PRODUCT SAFETY RECALL

SUBJECT: Passenger Airbag Inflator Weld May Fracture Upon Airbag Deployment

MODELS: 2014 Chevrolet Silverado Crew Cab
2014 GMC Sierra Crew Cab

3560199

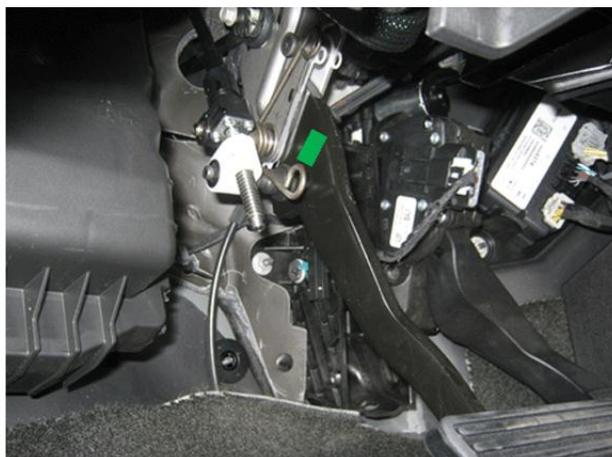
Determine if the instrument panel airbag has been replaced.

- If there is green paint stripe or green dot on the upper brake pedal arm, do NOT replace the instrument panel airbag. No further action is required.
- If a green paint stripe or green dot on the upper brake pedal arm is NOT present, replace the instrument panel airbag. Refer to the service procedure in this bulletin.

1. Remove the instrument panel airbag. Refer to *Instrument Panel Airbag Replacement* in SI.
2. Install a new instrument panel airbag. Refer to *Instrument Panel Airbag Replacement* in SI.
